DRESDEN NUCLEAR POWER STATION, UNIT 2

AMENDMENT TO PROVISIONAL OPERATING LICENSE

Amendment No. 75
License No. DPR-19

ATTACHMENT TO LICENSE AMENDMENT NO. 75

Figure 3.5-2 (Sheet 1 of 2) MCPR Limit for Reduced Core Flow

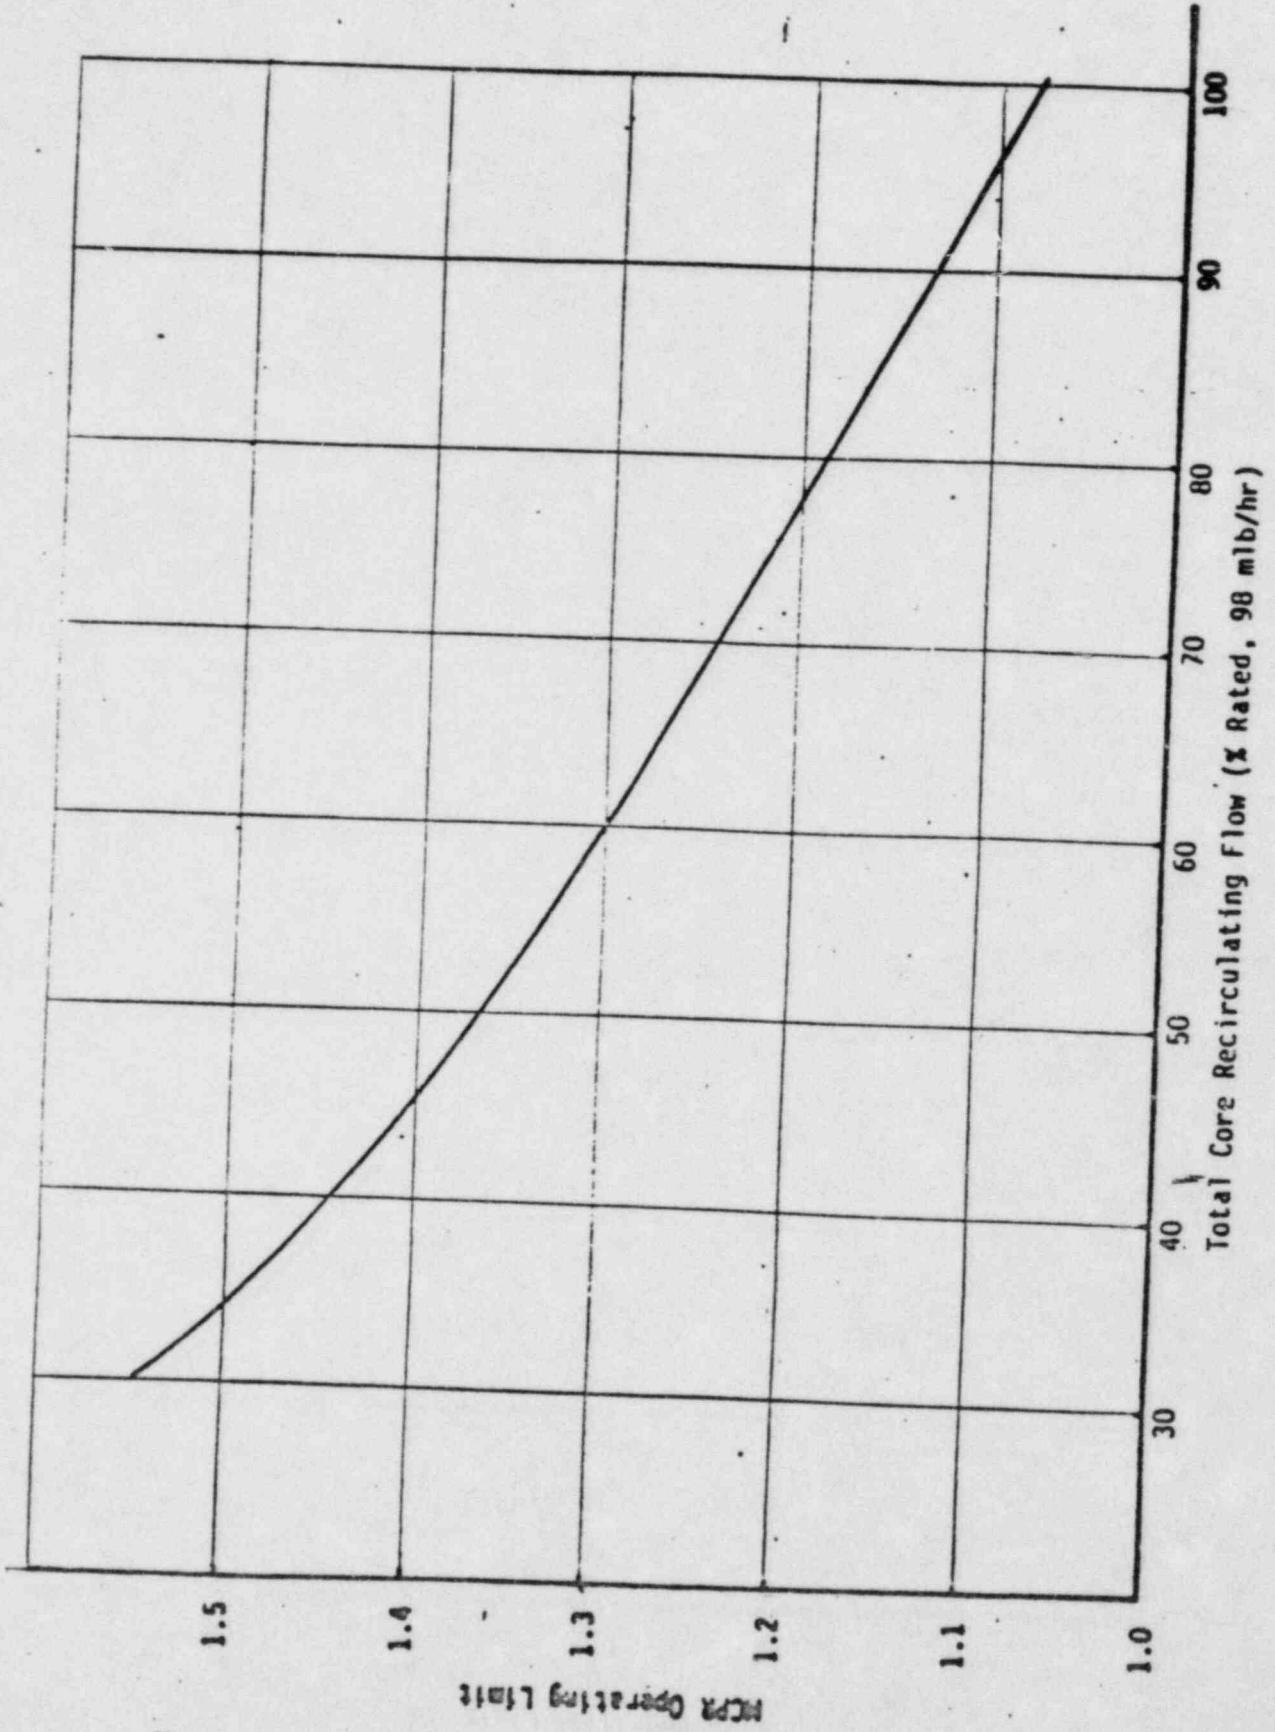
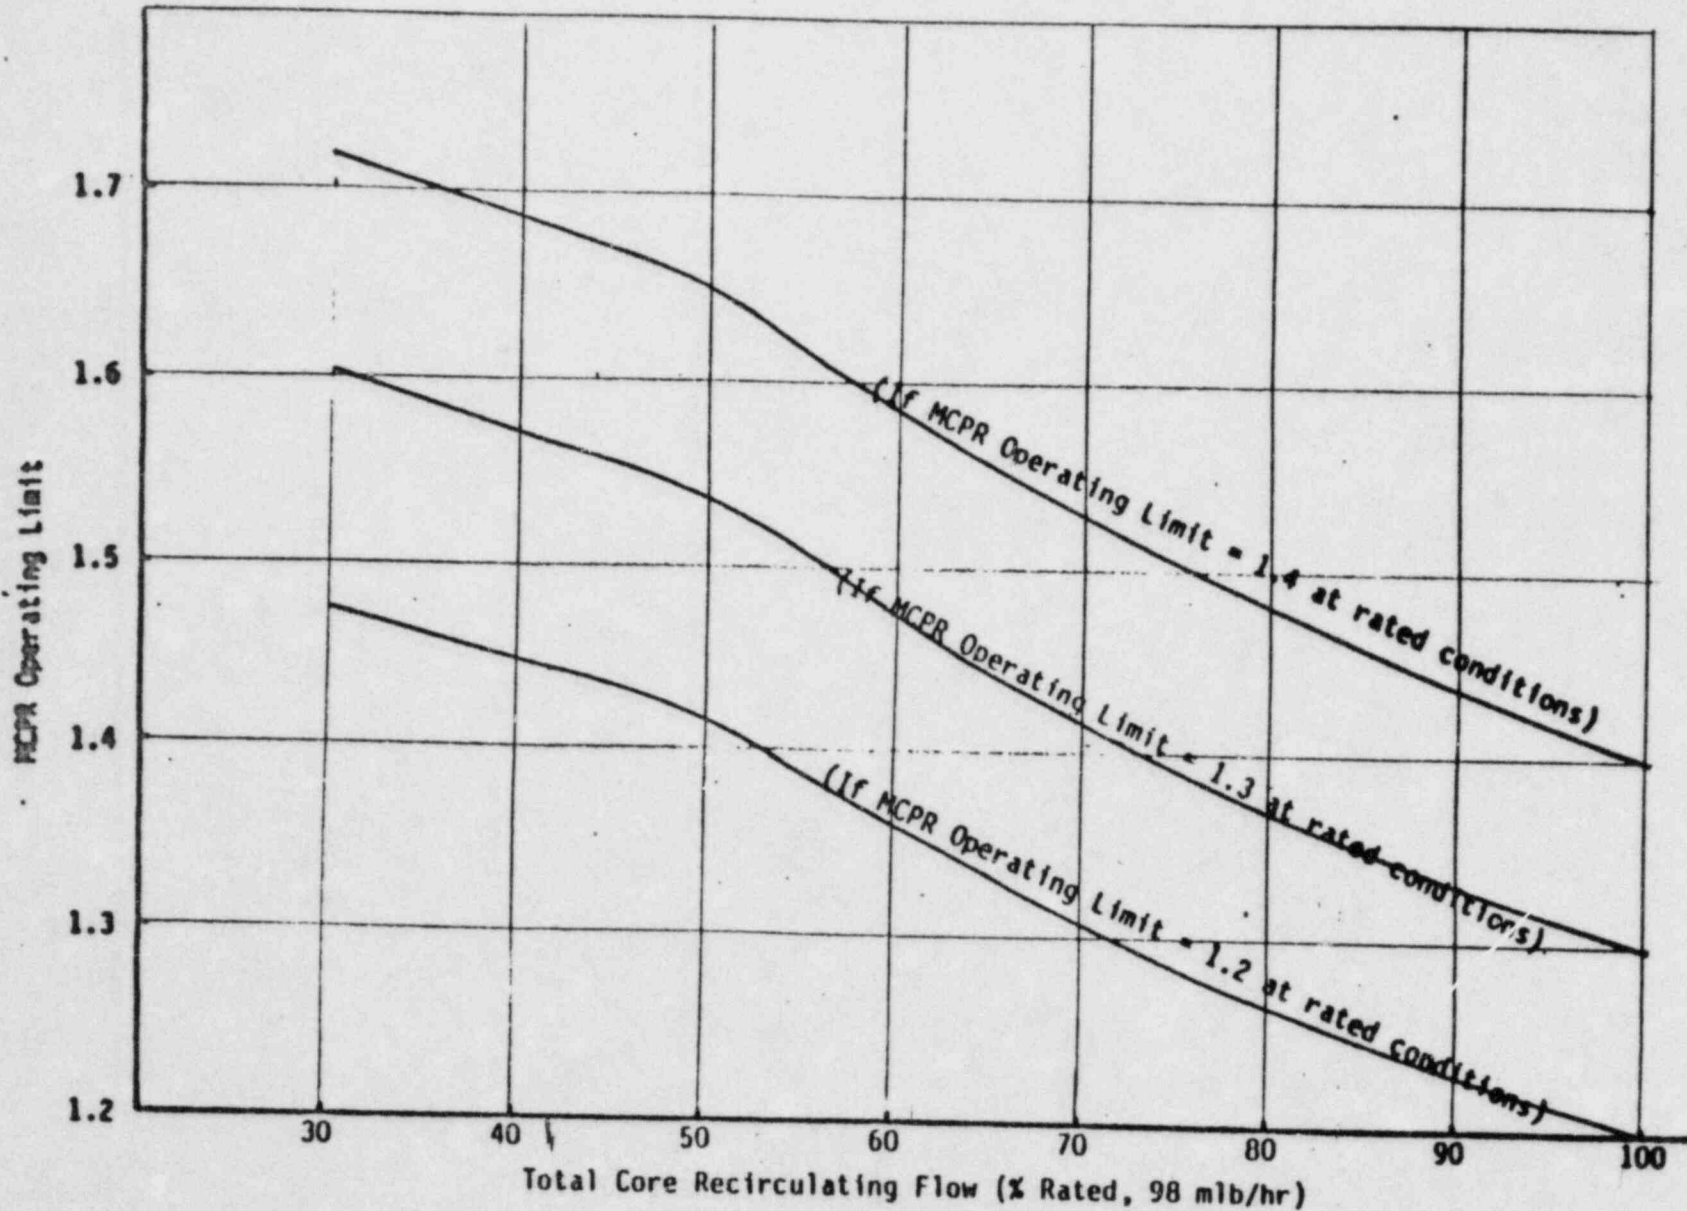
- 3.M.2 The Minimum Critical Power Ratio (MCPR) Safety Limit will be increased 0.03 (TS 1.1.A and 3.3.B.5.C)
- 3.M.3 The MCPR Limiting Condition for Operation (LCO) will be increased 0.03 (TS 3.5.K and Fig. 3.5-2)
- 3.M.4 The Maximum Average Planar Linear Heat Generation Rate (MAPLHGR) limits will be reduced to 70% of current values for all fuel types.

1. Manual Flow Control-the MCPR Operating Limit shall be the value from Figure 3.5-2 sheet 1 or the above rated core flow value, whichever is greater.
2. Automatic Flow Control-the MCPR Operating Limit shall be the value from Figure 3.5-2 Sheet 1, Sheet 2 or the above rated core flow value, whichever is greatest.
